REPORT CONTENT

- 1) Proposed development: Façade change, Site Change
- 2) Noticing was completed on: Click or tap to enter a date.
- 3) The neighborhood meeting was held on: Click or tap to enter a date.

- 4) Associated Conditional Use Permit: CUPFY2026-0001
- 5) Site Coverage:
 - a) Building: # SF, % of the site
 - b) Landscaping: # SF, % of the site
 - c) Paved Areas: # SF, % of the site

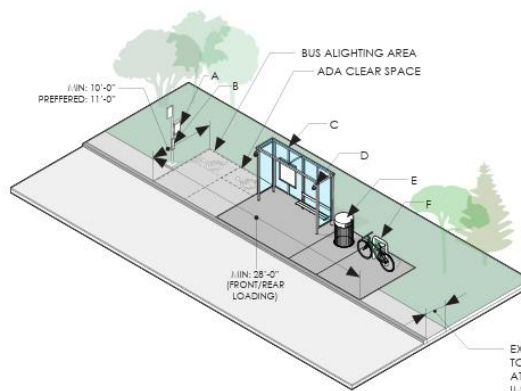
Existing transit service is provided along the corridor by Valley Regional Transit (VRT), with a bus stop located immediately adjacent to the project frontage. While the bus stop is not included within the scope of the proposed improvements, it is directly connected to the site. VRT has identified this stop as a medium-sized transit stop; however, the existing facility functions more like a small-sized stop, consisting of a bench located on a widened section of sidewalk.

Opportunities to expand the stop to the west are constrained by the presence of a mature tree, making expansion in that direction impractical. However, sufficient space exists within the landscaped area to the east of the stop to accommodate future improvements.

VRT has indicated that extending the concrete pad approximately 18 feet into this area would provide adequate space for installation of a transit shelter, bicycle rack, and other passenger amenities, allowing the stop to function as a medium-sized transit facility.

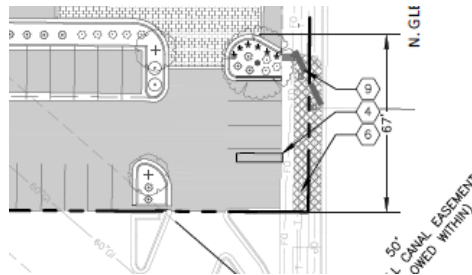
The parking lot is in a preexisting location. The applicant provided an updated landscaping and parking design for the surface parking area. However, there is a missing landscape buffer along Glenwood Street that needs to be addressed.

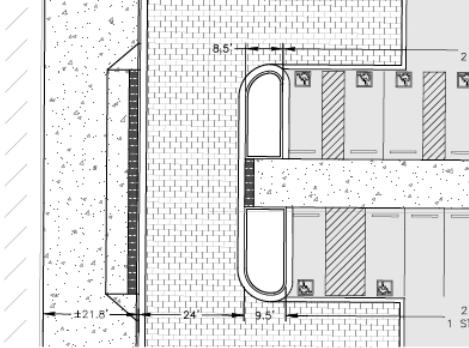
Driveways are greater than 22 feet wide. The transportation agency did not provide comments at this time. Discussion is required.

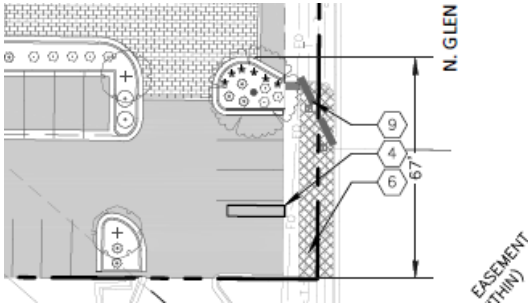
Provided: 5 trees. Glenwood Street (~368 LF): 1 Street tree + 7 Frontage trees = 8 trees Provided: 2 exiting trees. All new trees are proposed outside of the existing green buffer area along the street. Clarification is required. A minimum of one tree per one thousand (1,000) square feet of landscaped area and one shrub per one hundred fifty (150) square feet of landscaped area shall be planted. 22,446 SF/1,000 SF= 22 trees Provided: 62 trees Minimum required: 22,446 SF /150 SF= 150 shrubs; Provided: Proposed: 232 shrubs. Ensure that the required landscape areas are at least seventy percent (70%) covered with vegetation at maturity. Note: Staff recommends requiring Class II street trees (or larger where planting strip width allows) along public frontages to maximize cooling, public health, habitat, stormwater, and long-term canopy outcomes; Class I trees should only be permitted where overhead utilities or substandard planter widths preclude larger forms. This is consistent with regional practices and local streetscape precedents of new developments in Garden City. Conditions have been drafted to allow Class I trees in lieu of Class II or Class III trees due to overhead utilities along Chinden and Glenwood.

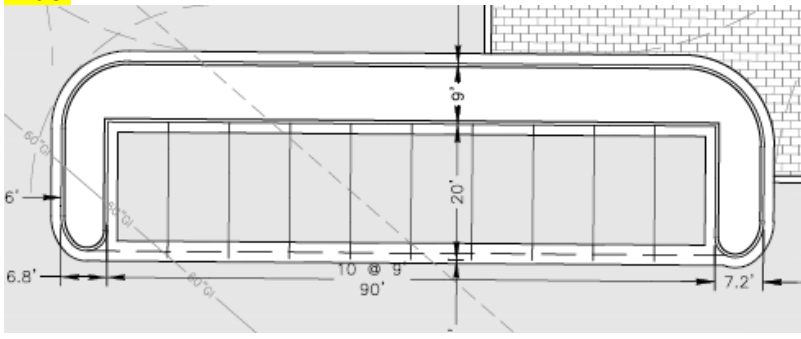
8-4I-5 Perimeter Landscaping Provisions	May not be compliant	Type B Filtered Screen Landscaping is required in the following circumstances: - Along surface parking areas greater than three (3) cars adjacent to public streets. Type B perimeter landscaping is required along the parking lot frontage on Chinden Boulevard and Glenwood Street. A portion of the parking lot is not screened along Glenwood.  The selected plant materials may be a mix of deciduous and evergreen varieties so that the following is achieved: - Visual interest during the winter months; and - The landscaping provides a visual separation, but not a complete visual barrier.
8-4I-6 Parking Lot	May not be compliant	Plant materials for parking lot landscape areas shall be selected for suitability in that environment:

Landscaping Provisions		a. Native and non-native plant species that are hardy, drought tolerant, and resistant to the stresses of compacted soils and weather exposure shall be used; b. Suitable native species shall be included where possible and appropriate; c. Monocultures which can be susceptible to disease shall be avoided; e. Consideration to the sun, shade and irrigation requirements shall be made; and f. A variety of deciduous and coniferous trees and shrubs for year round interest, texture, shape and seasonal color shall be planted. Edge treatments along streets and other public spaces shall visually screen parked vehicles, but not completely obstruct views into and out of the parking lot for the purpose of supporting pedestrian safety and security. Internal landscaped areas shall be designed with a curb to prevent damage from vehicles, to separate planting areas from pedestrian pathways, and to prevent soil and other landscape material from spreading over adjacent surfaces. a. Taller or shorter curbs are permitted where vehicle overhang and door clearances are not an issue. b. Curb cuts are permitted to the extent needed to support accessibility and stormwater initiatives. Plant high branching deciduous trees throughout the parking lot interior to provide shade for pedestrians, vehicles and surfaces. Internal shade trees shall be provided at a minimum ratio of one tree planted for every five (5) parking spaces supplied. Internal shade trees shall be planted such that no parking space is more than one hundred feet (100') from a tree. Include landscaped islands with at least one tree at the beginning and end of each parking row and to break up longer rows or highlight special features. A continuous landscape median at least ten feet (10') in width shall be provided every three (3) banks of parking (a bank is 2 rows of parking and a drive aisle). Based on the proposed parking layout, staff cannot determine whether this requirement is met. It appears that not every third bank of parking is separated by a 10-foot-wide landscape median. Additionally, one of the proposed landscape medians is less than 10 feet wide.
